TM-F21-0006 Exhibit A: Assessor's Parcel Map

**CAMPOBELLO UNIT 1**

**TM-F21-0006 Exhibit F**  
**Conditions of Approval Conformance Verification**  
**For Campobello Unit One Final Map**

The following is the verification of conformance of the proposed Campobello Unit One Final Map with the approved Campobello Unit One Tentative Subdivision Map (TM05-1403-R) and applicable conditions of approval as approved by the Planning Commission on June 14, 2018.

SHEET 3 OF 5

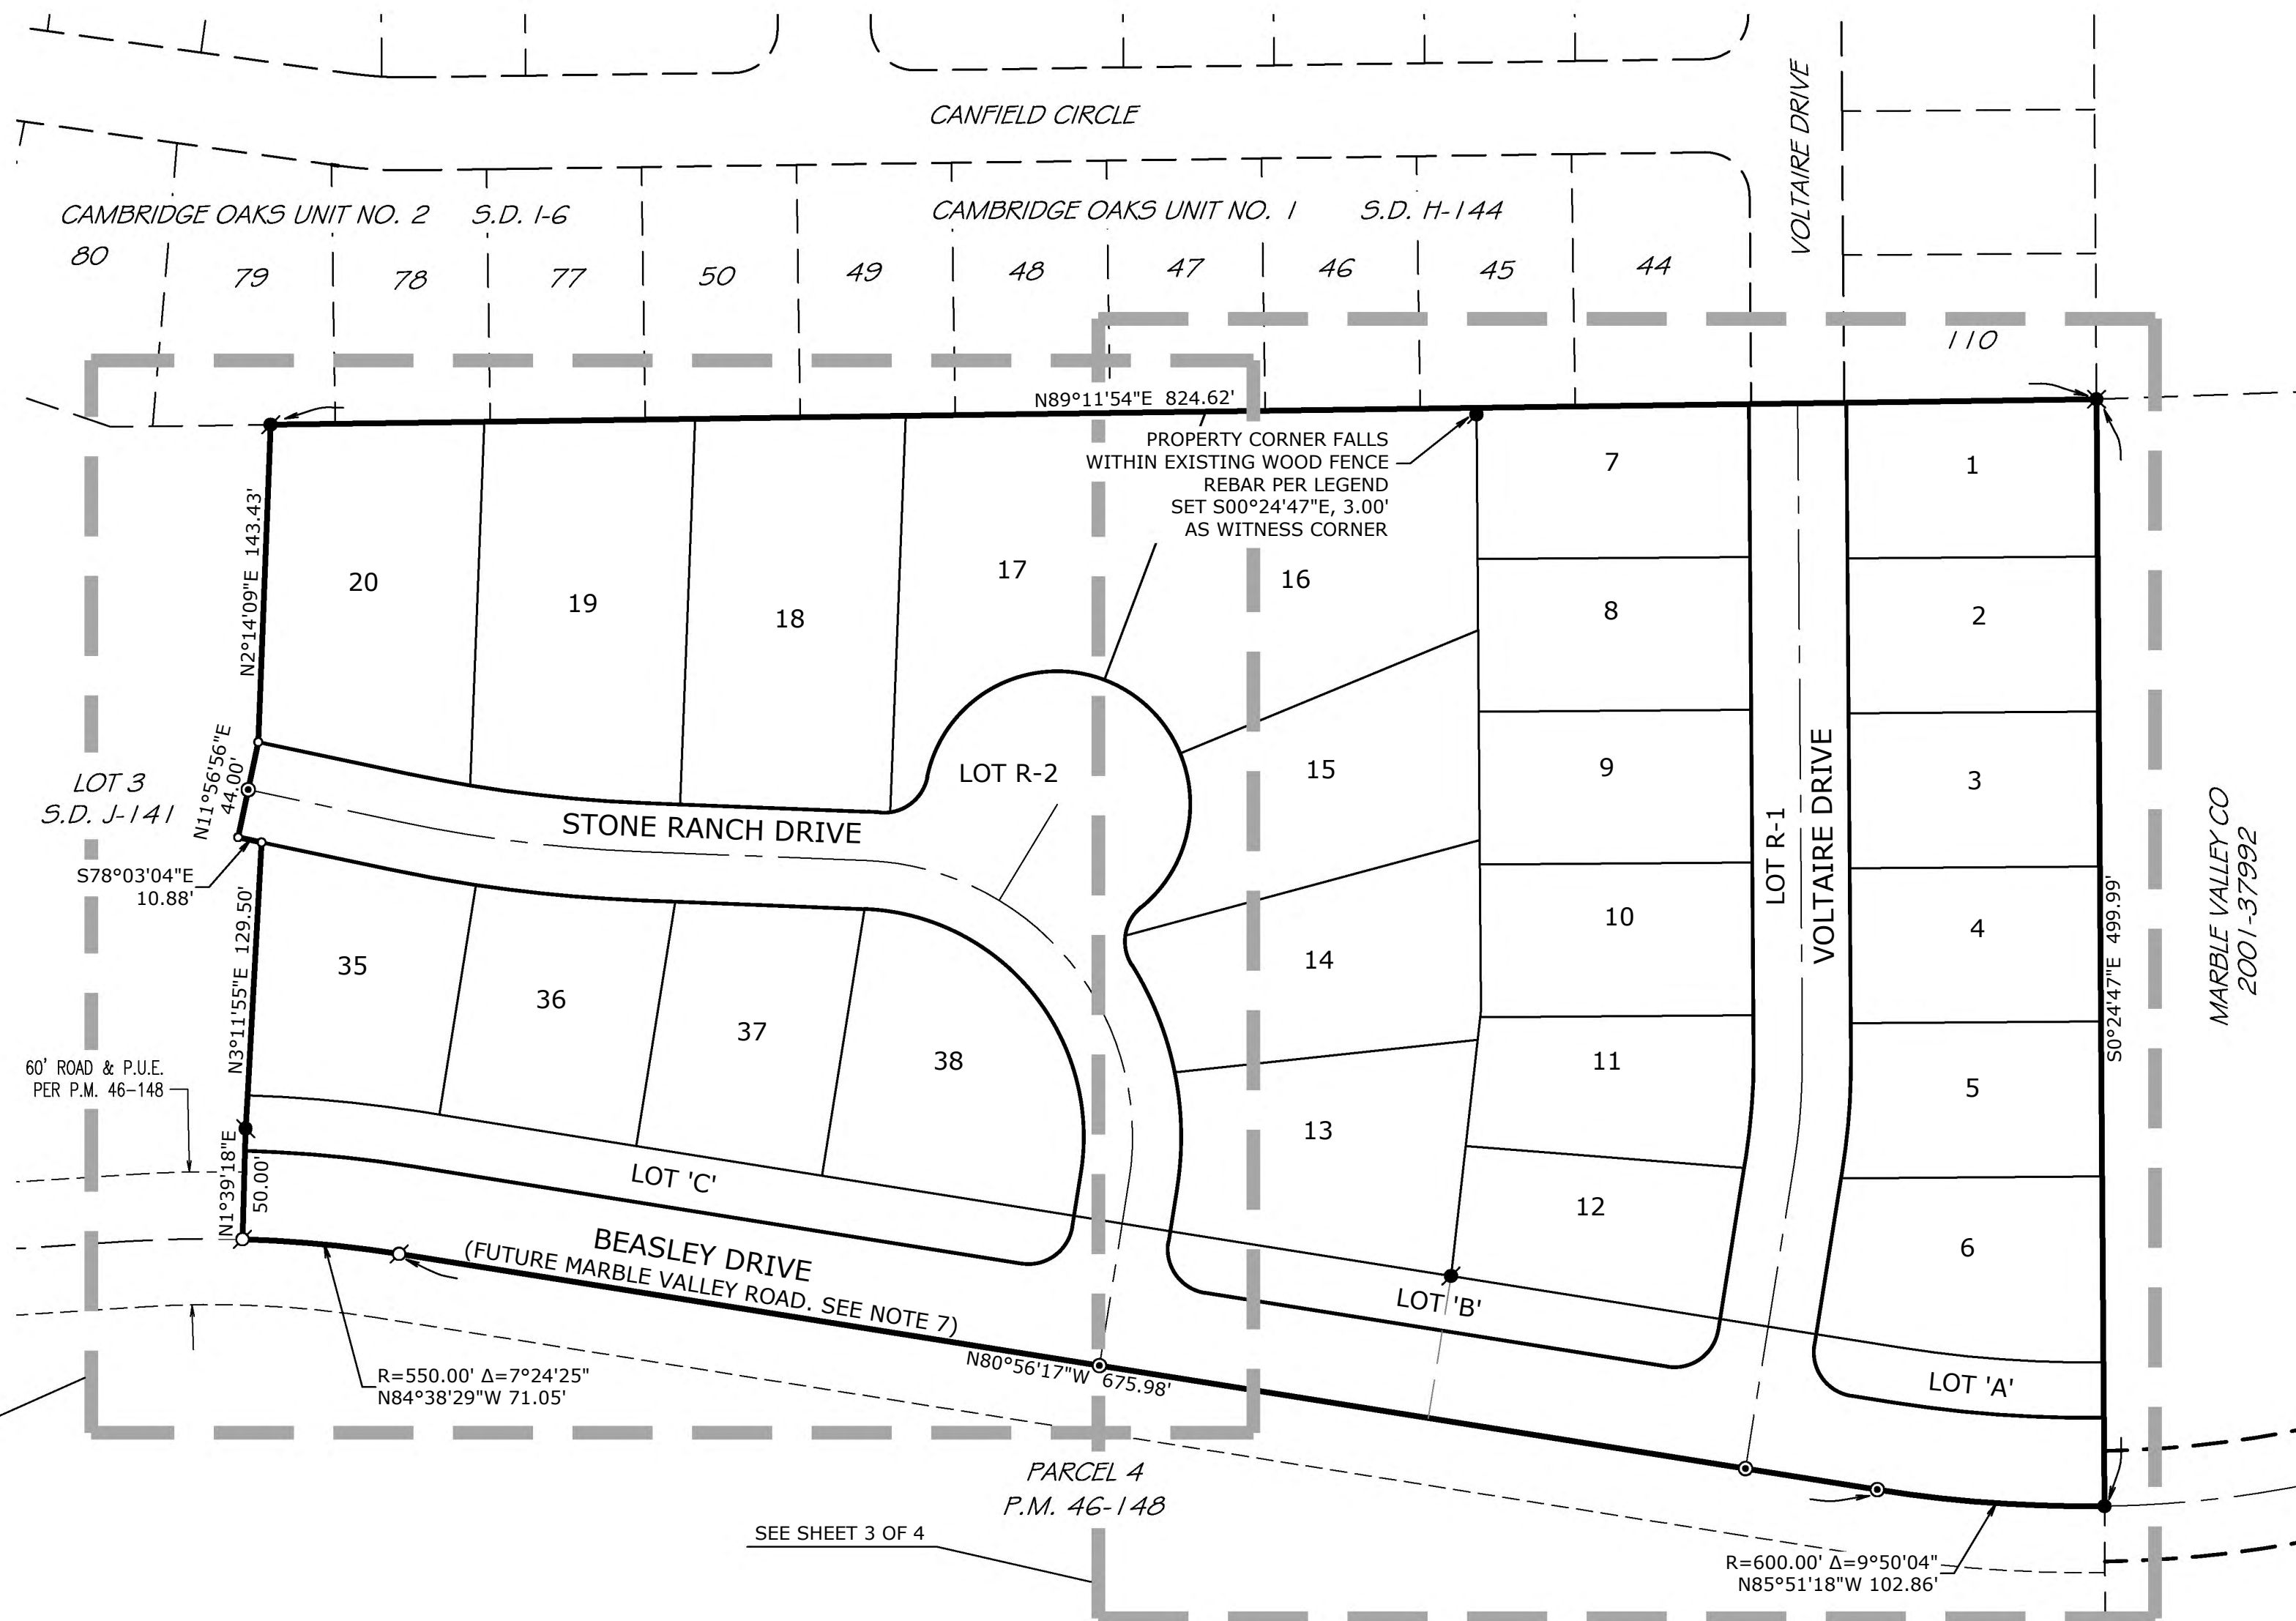
- 12. The applicant shall irrevocably offer to dedicate (IOD), in fee, 40-feet of right of way along the entire onsite frontage of Marble Valley Road, with the appropriate slope easements. This offer will be accepted by the County.

*Staff Response: The Final Map includes the dedication of the Marble Valley Road right of way as note number two on sheet three of the final map plan sheets. Therefore, the project is consistent with this condition.*
